Project Description / Description de projet U61 Re-roof Sections 1, 2, 6, 7 & 8		
Solicitation No./N° de sollicitation 18-22120	Project No./N° de projet 5676	W.O. No./N° d'ordre de travail A1-011227-11-01
Departmental Representative / représentant ministériel Maurice Richard		Date March 20, 2019
<p>Notice: This addendum shall form part of the tender documents and all conditions shall apply and be read in conjunction with the original plans and specifications.</p>	<p>Nota: Cet addenda fait partie intégrale des dossiers d'appel; toutes les conditions énoncées doivent être lues et appliquées en conjonction avec les plans et les devis originaux.</p>

3.1 Additional Scope

project: **U-61 HANGAR ROOFTOP GPS ANTENNA MOUNTING BRACKETS UPLANDS**
 drawing: **FLOOR PLAN, SECTION + DETAILS**

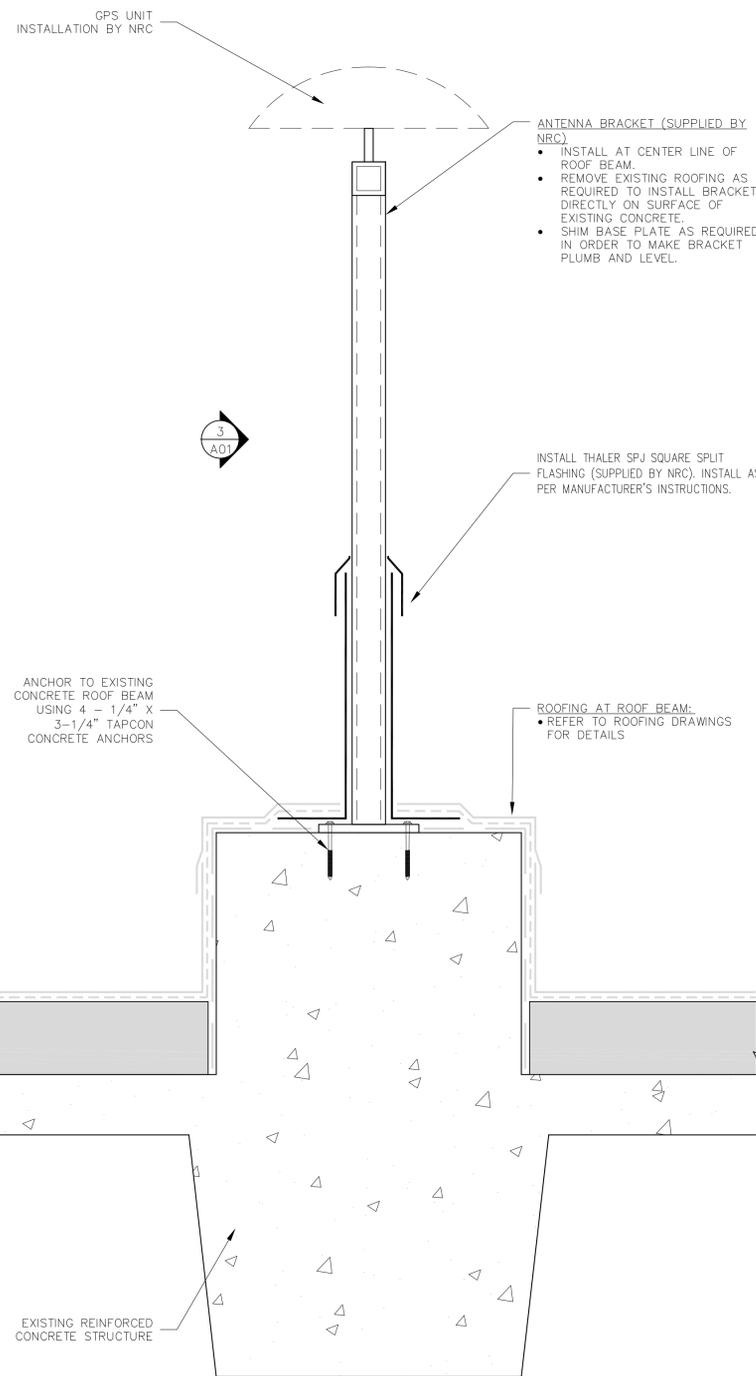
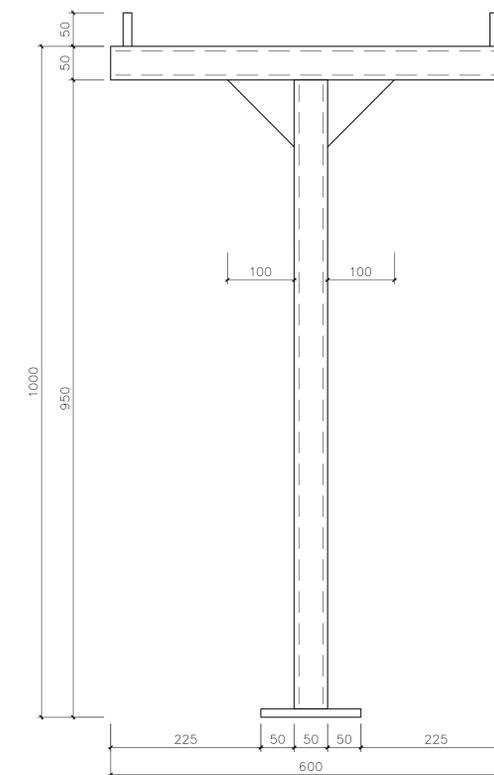
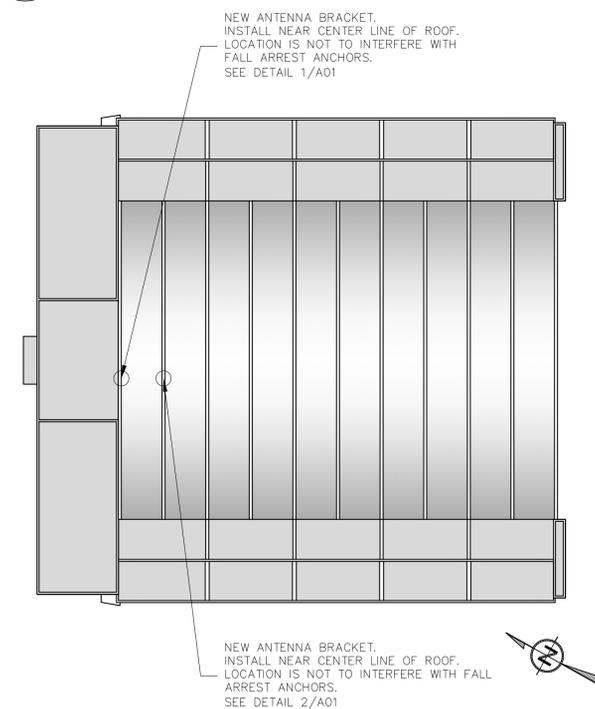
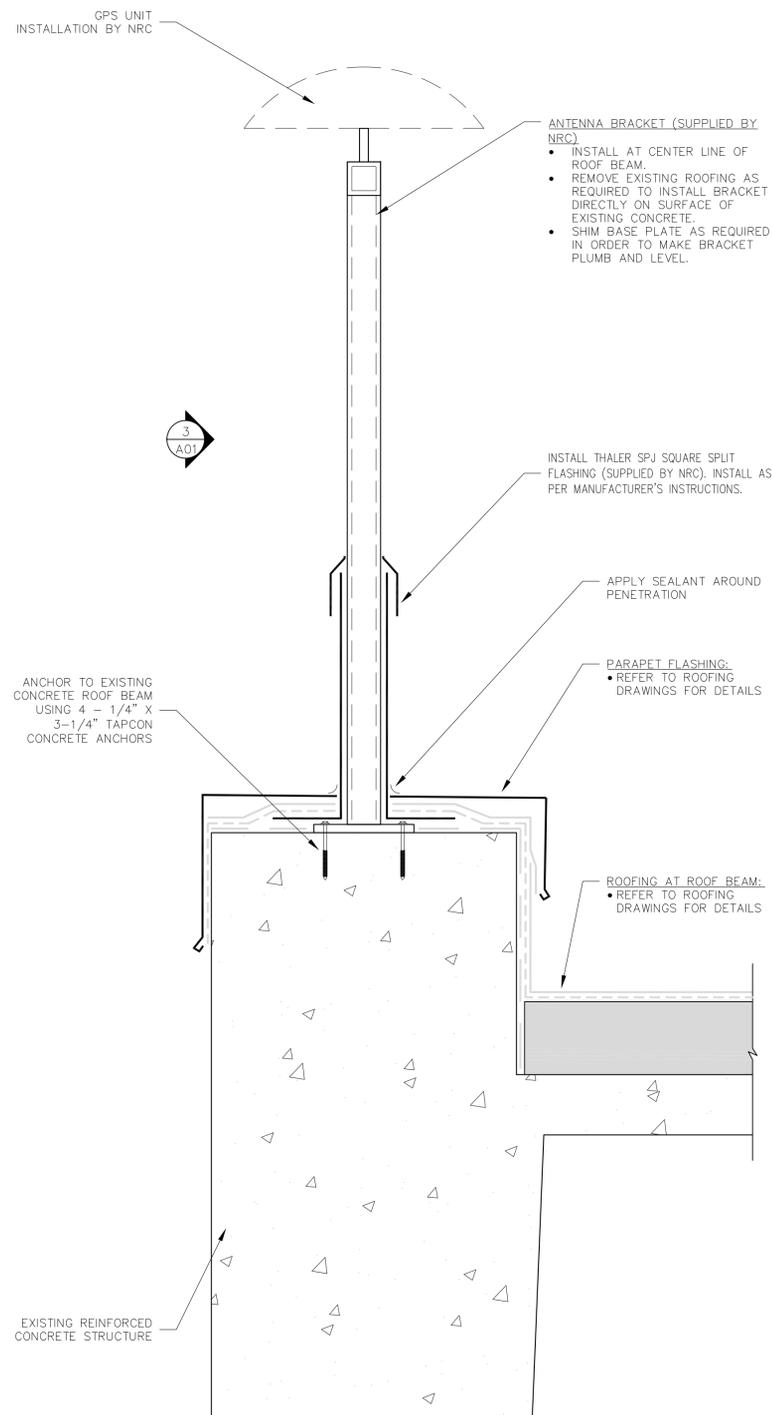
Provide installation of two NRC supplied Thaler products for NRC roof antennas, per drawing 5676-A01.
